**Notice of Intent**

**Type of Action:** Plug and Abandonment

**DJR Operating, LLC  
Plug and Abandonment Procedure  
Jicarilla I 163 1  
API # 30-043-05197  
NE/NE, Unit A, Sec. 23, T23N, R2W  
Sandoval County, NM**

**UNITED STATES DEPARTMENT OF THE INTERIOR  
BUREAU OF LAND MANAGEMENT  
FARMINGTON DISTRICT OFFICE  
6251 COLLEGE BLVD.  
FARMINGTON, NEW MEXICO 87402**

**Proposed Wellbore Diagram**  
**DJR Operating, LLC**  
**Jicarilla I 163 1**  
**API # 30-043-05197**  
**NE/NE, Unit A, Sec 23, T23N, R2W**  
**Sandoval County, NM**

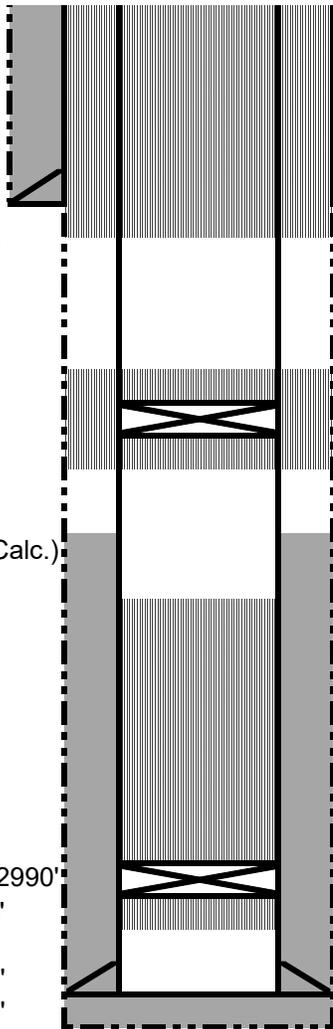
You are also required to place cement excesses per 4.2 and 4.4 of the attached General Requirements.
